## **Morses Pond Beach Advisory Committee Recommendations and Considerations**

### **Morses Pond Beach and Bathhouse Project Goal**

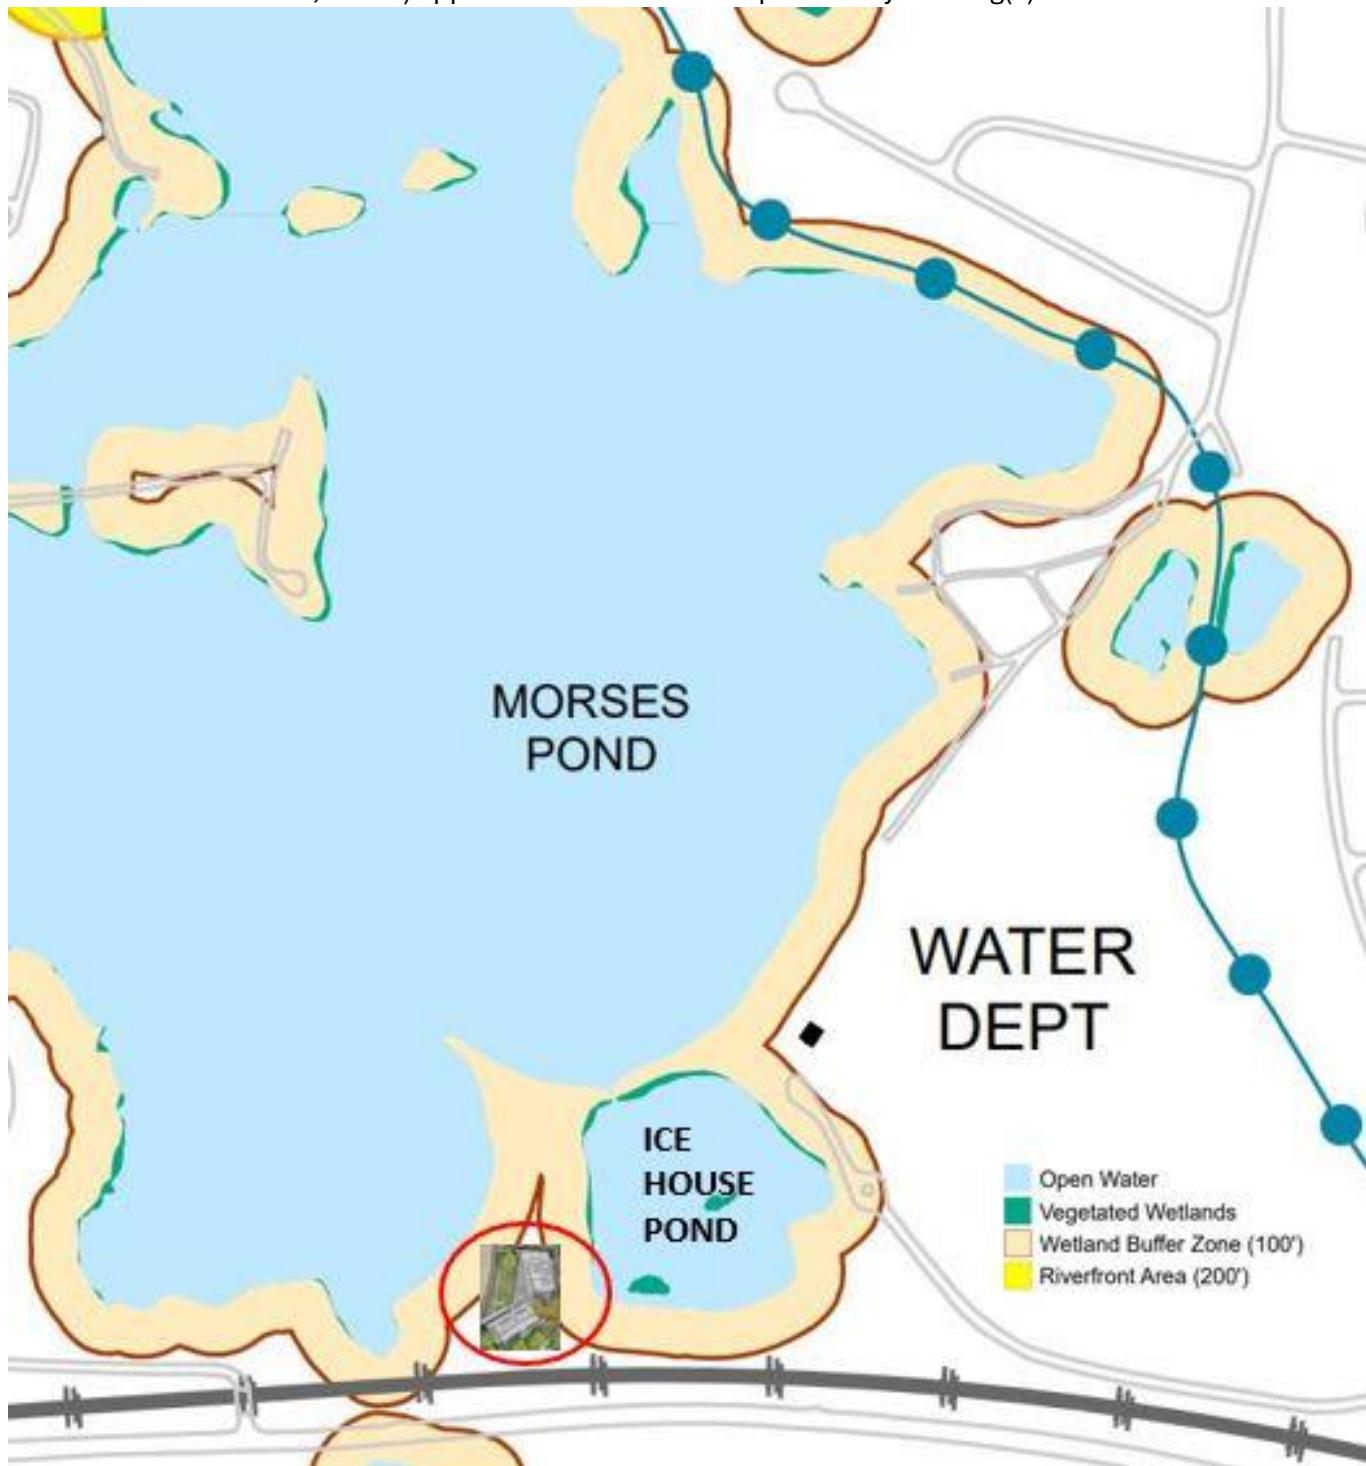
The project will have to go through the Wetlands permitting process, irrespective of the location of any building(s) that are proximate to the beach. Placing the building(s) within the existing building footprint or other Wetlands Buffer Zone locations proximate to the beach are not precluded, subject to approval by the Wellesley Wetlands Protection Committee and any other relevant regulatory bodies. The currently proposed location (approximate location shown in red circle, below) appears to minimize the impact of any building(s) on the Wetlands Buffer Zone.

Consider removing the proposed 730 foot path (circled in red, below), abutting the access road, on south side of Ice House pond, located in 25 foot No Disturbance Zone. Consider utilizing a north entrance gate to admit season pass holders and existing west side pathway, separated from the beach by a fence and shrubbery, for daily pass purchasers entrance at administrative building.

Consider removing the proposed, new 470 foot path (circled in yellow, below), on west side of Ice House pond, located in 25 foot No Disturbance Zone. Consider utilizing a north entrance gate to admit season pass holders and existing west side pathway, separated from the beach by a fence and shrubbery, for daily pass purchasers entrance at administrative building. The NRC also recommends analysis of the footbridge between Ice House and Morses ponds to ensure its structural integrity identify any needed.

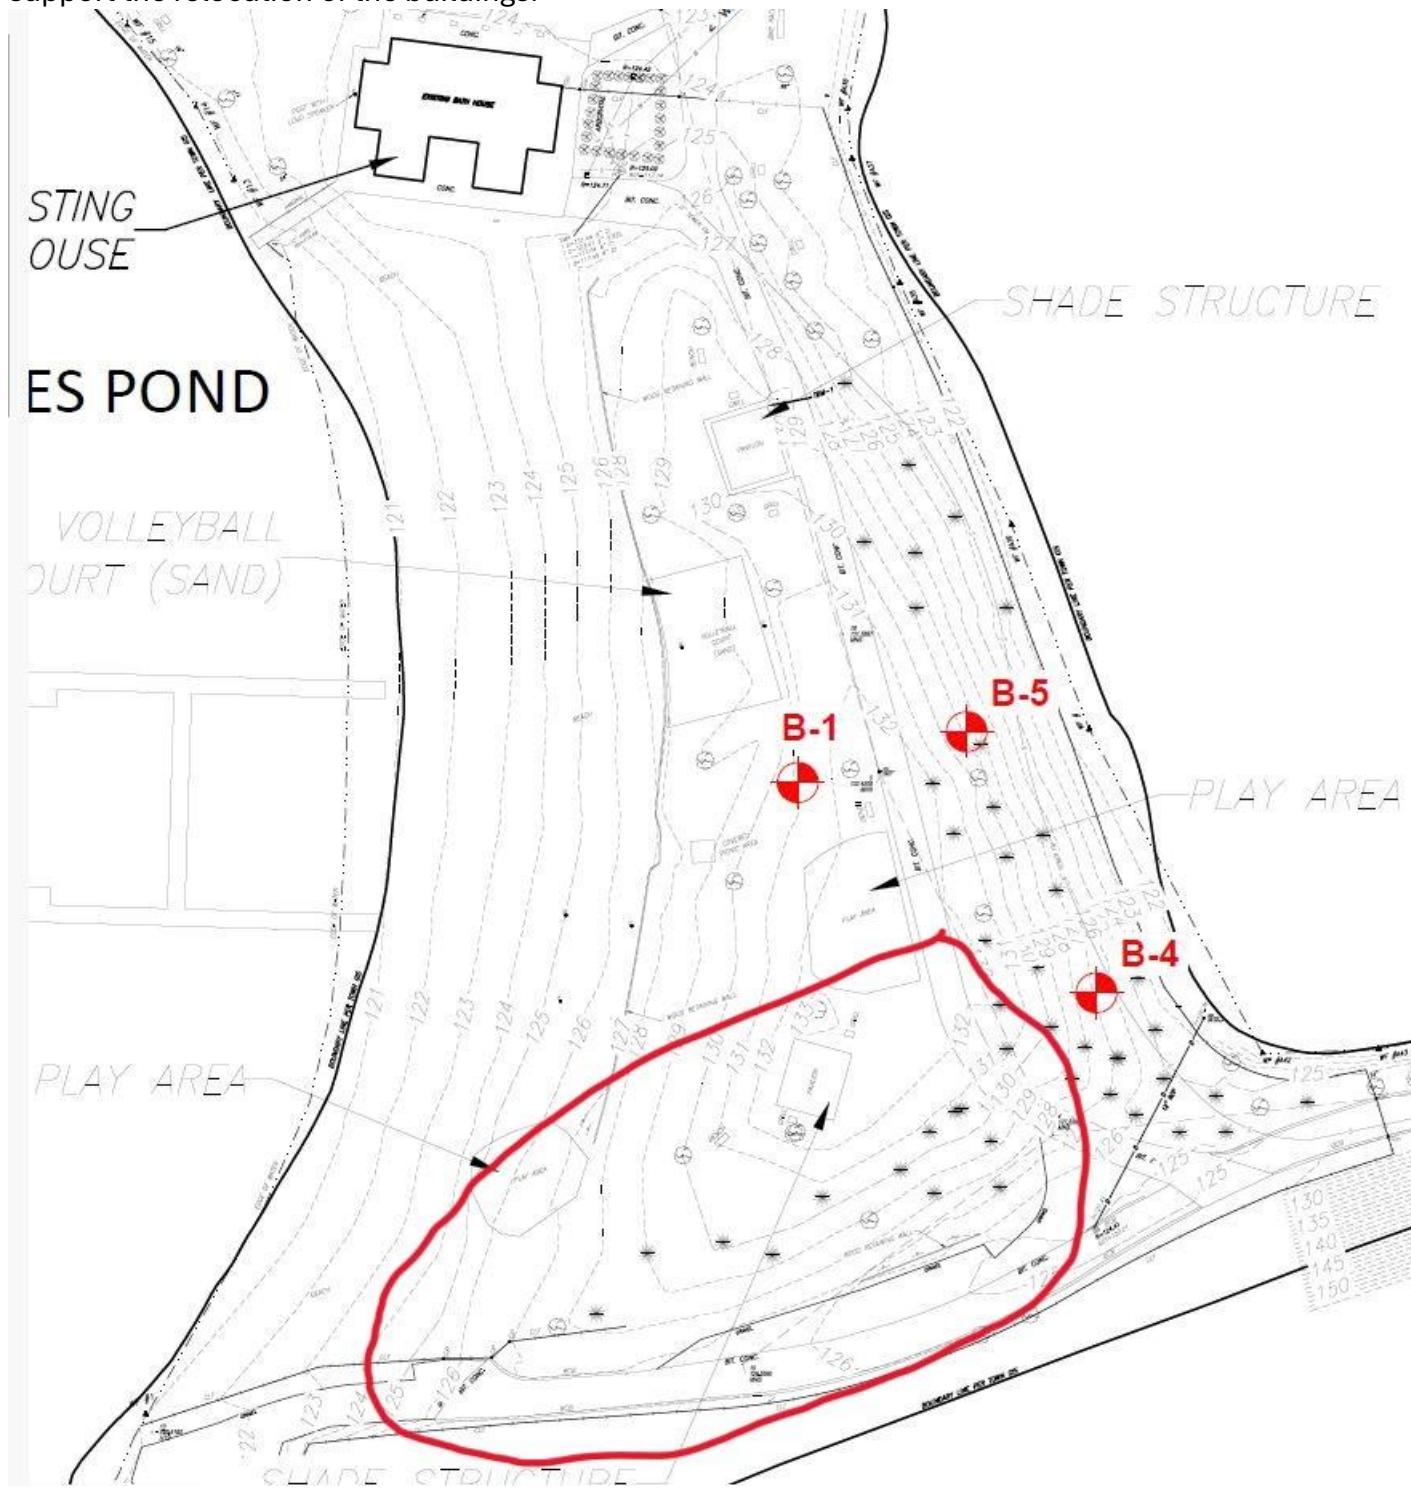
To minimize the amount of impervious surface impact on stormwater and in order to preserve as much natural open space as possible, consider reducing the overall size of the combined footprint of the building or buildings while allowing the buildings to still meet Rec's operational and programmatic needs. Possible areas to consider for reduction include:

- Reduction in the size of the men's and women's bathrooms
- Reduction in the size and/or possible relocation of the large storage areas in bathhouse, If relocated, evaluate opportunities to reduce impervious surface impact

- Reduction in the size of the gatekeeper's room
- Reduction in the size of the concession room to accommodate vending machines only. Consider food truck use for other food & beverage needs
- Reduction in the size of the first aid room

or other alternatives proposed by Rec. While not suggesting limiting the toilet count to the following minimum requirements, MA 248 CMR10.10, Uniform State Plumbing Code, requires at public beaches, a minimum of 1 female toilets per 500 patrons and 1 male toilets per 1,000 patrons.
